U.S. ENVIRONMENTAL PROTECTION AGENCY
COMMENTS ON THE TECHNICAL MEMORANDUM 1
OPERABLE UNIT 5, ROCKY FLATS PLANT

FIG. 1

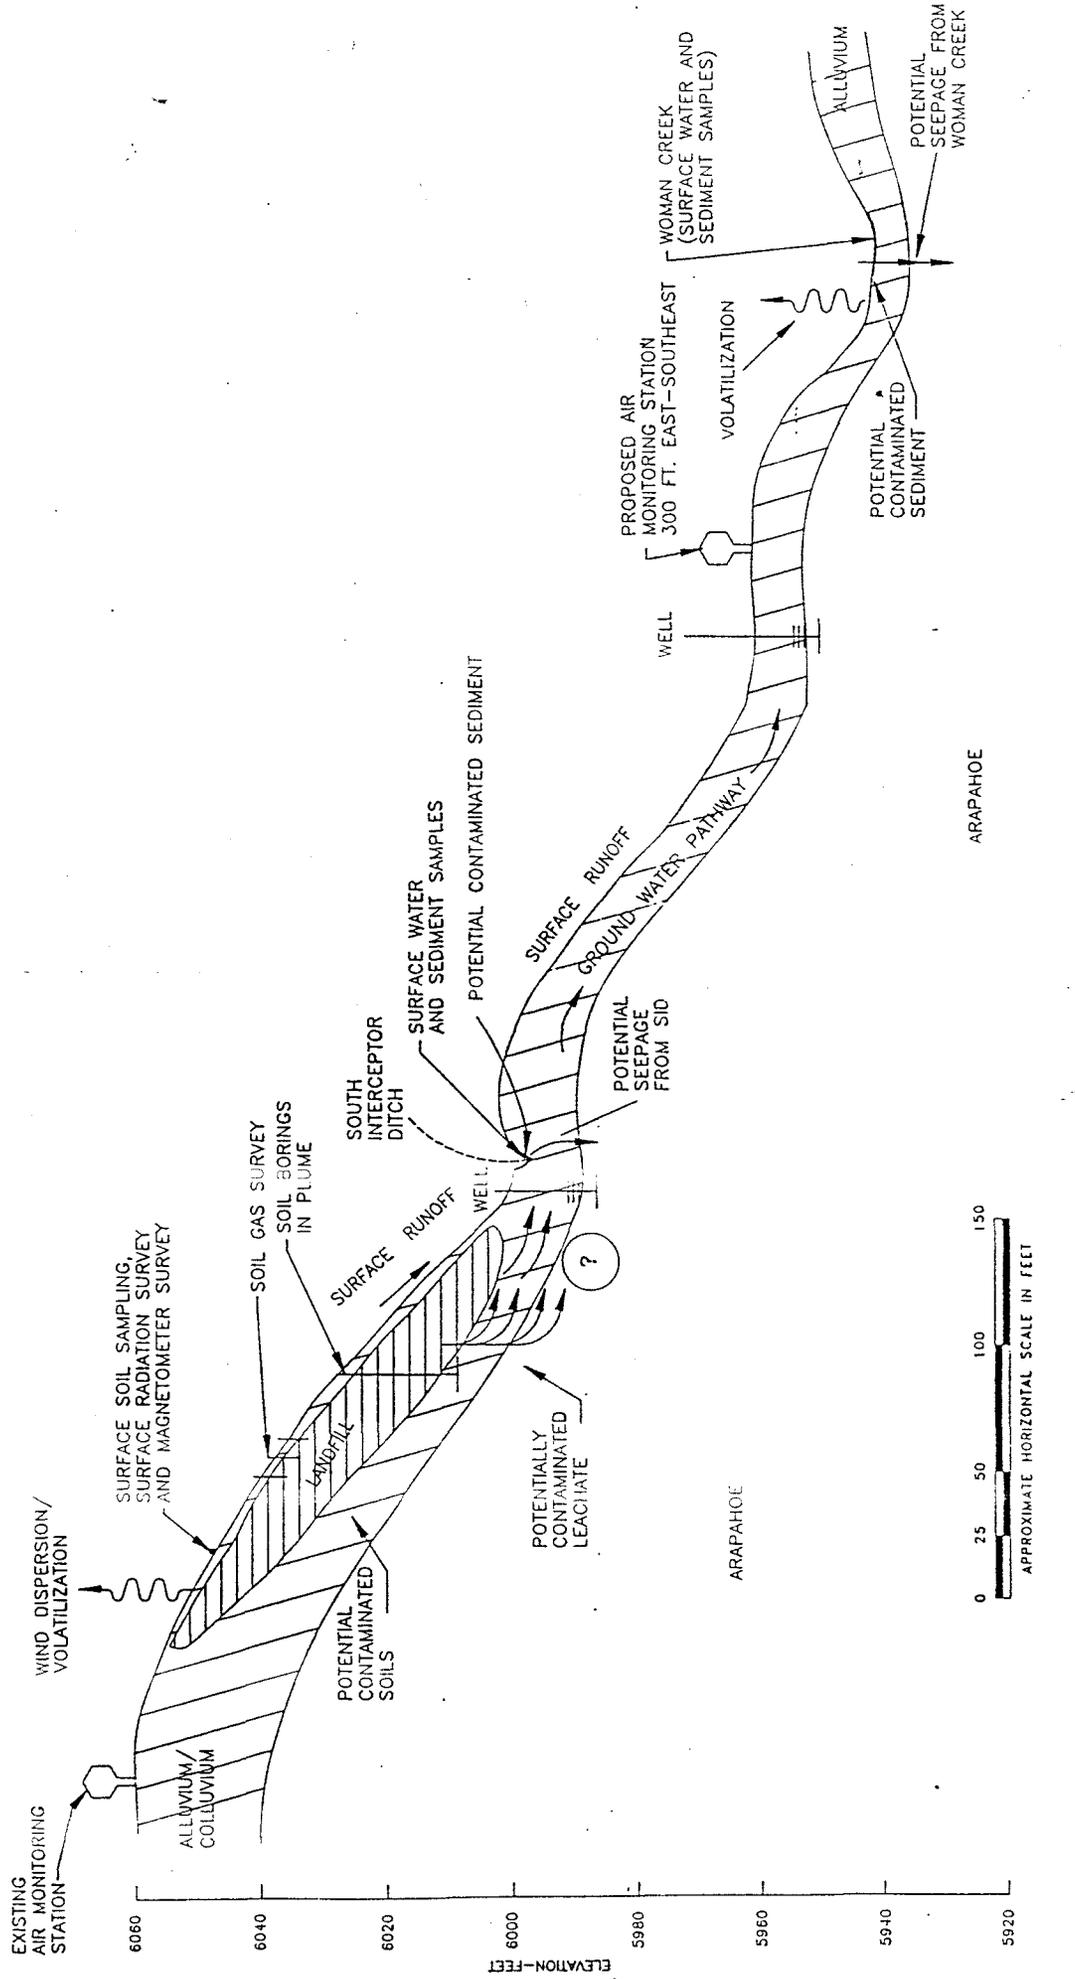
2. Page 7-9, Stage 3: We believe the proposed surface soil sampling program of four grab samples in the landfill area is inadequate. In light of recent developments in the OU 1 soil sampling program, DOE must redesign this program and focus on the exposure pathways (both human health and environmental) which will be characterized by this data and the required number of samples and sampling technique. Given that DOE already has some preliminary information from the radiation survey of the landfill, EPA suggests that DOE consider establishing a separate grid over the hot spots to provide a biased sampling for radionuclides and establishing another grid over the entire area for random sampling for other contaminants. DOE's program must be justified statistically in accordance with EPA's Guidance for Data Useability in Risk Assessment (EPA/540/G-90/008).

3. Page 7-15, Stage 3: We believe the proposed surface soil sampling program of four grab samples in the ash pit area is also inadequate. Please see our comment #2.

1. Surface Soil Sampling Program for IHSS 115 and IHSS 133
 - Include sampling locations, sampling protocol, and statistical justification
 - Addresses EPA comments #2 and #3
2. EM Geophysical and Magnetometer Survey for IHSS 115 and IHSS 133
 - Include instrument details, grid spacing, and field procedures
 - Addresses CDH's comments
3. Soil Gas Survey Grid for IHSS 115
 - Include the number of soil cores (depends on the grid spacing)
 - Addresses CDH's comments
4. Cone Penetrometer Program
 - Include instrument details, location, spacing, analytical program, and field procedures if not covered in existing SOPs
 - Addresses CDH's comments
5. Monitoring Well Program for IHSS 115 and 133
 - Include well locations and analytical program
 - Addresses CDH's comments
